RE: **Barrington Estates Drain, Sturgill Relocation**

**Drain-Improvement:** Barrington Estates - Sturgill Relocation

**Re: Barrington Estates Drain: Sturgill Relocation**

**HAMILTON COUNTY SURVEYOR'S OFFICE**  
**"AS-BUILT" RECORD DRAWING**  
**THORPE CREEK DRAIN/ STURGIS RELOCATION**  
**Barrington Estates Section II**

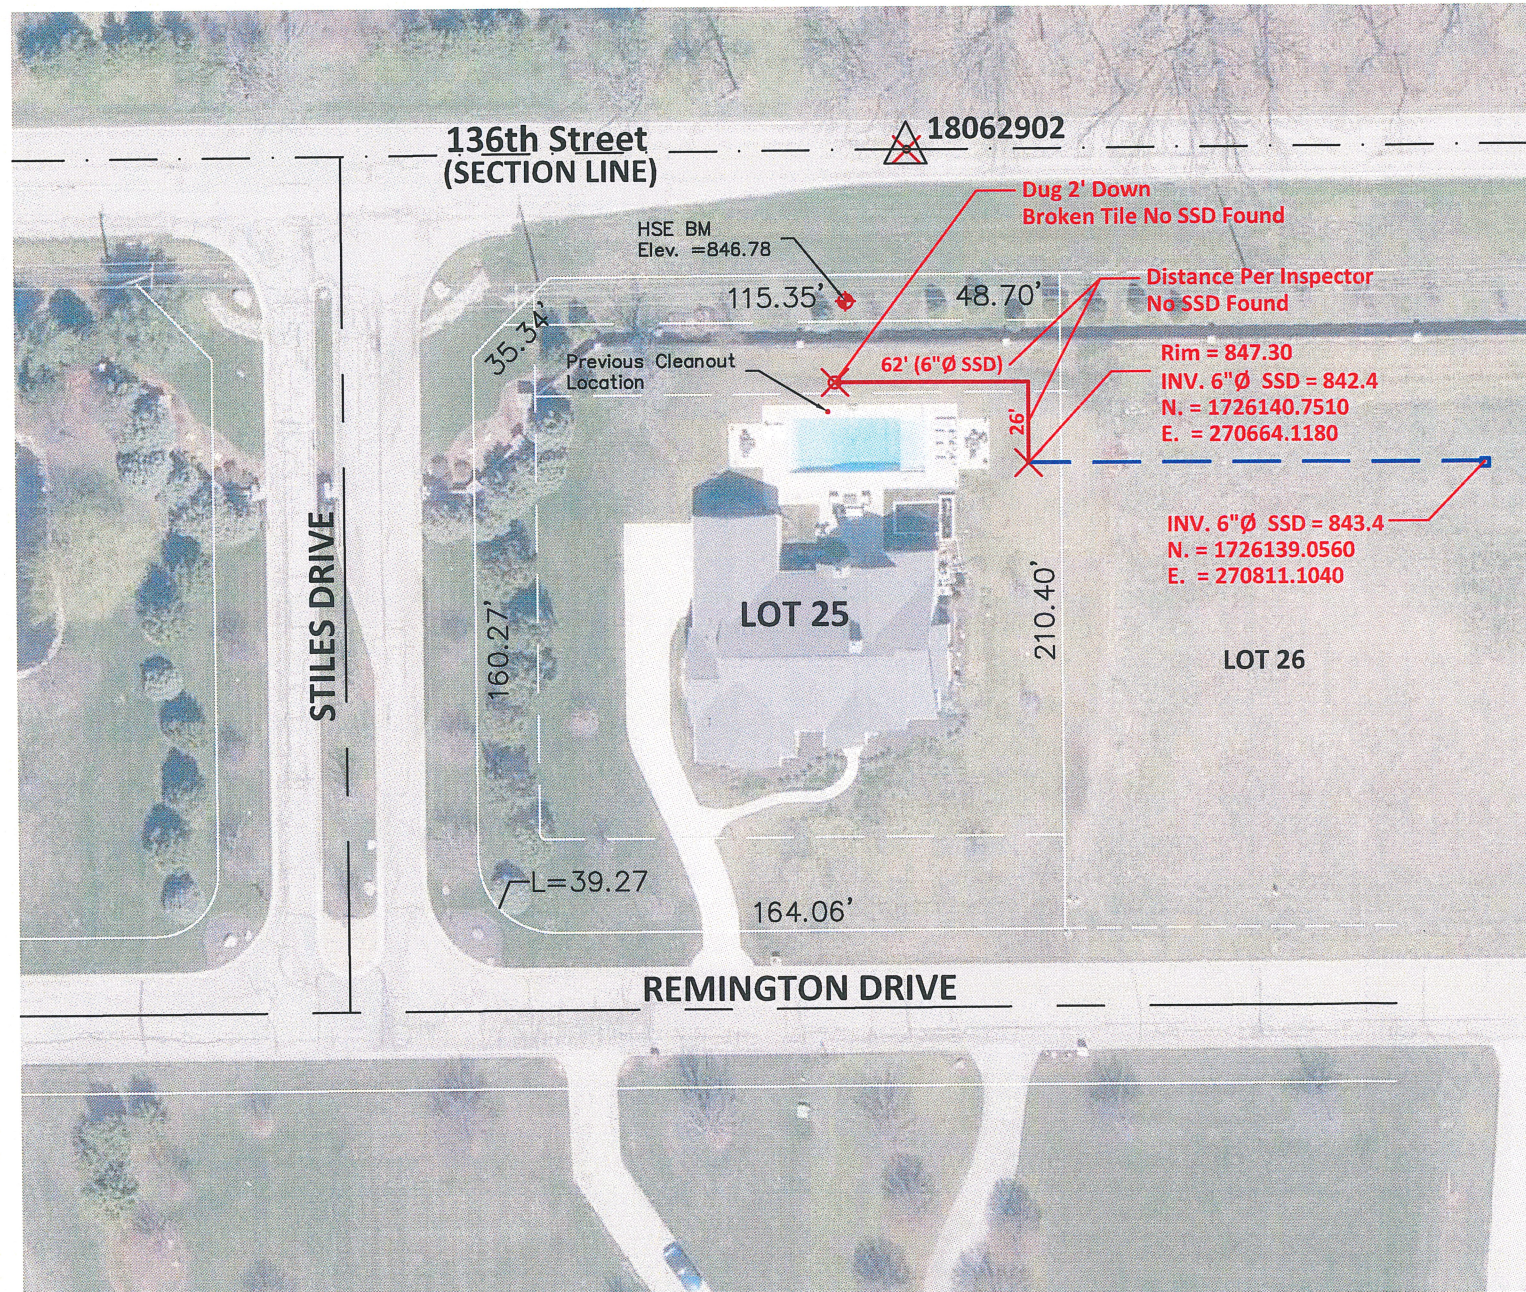
During construction, changes were made to the drain, which will alter the plans submitted with my report for this drain-dated April 6, 2016. The report was approved by the Board at the hearing held May 9, 2016. (See Drainage Board Minutes Book 16, Page 550) The changes are as follows: the 88 feet of 6" SSD was not installed. The length of the drain due to the changes described above is now **0 feet**. It should be noted that the existing 72 feet of 6" SSD was vacated.

I recommend the Board approve the drain's construction as complete and acceptable.
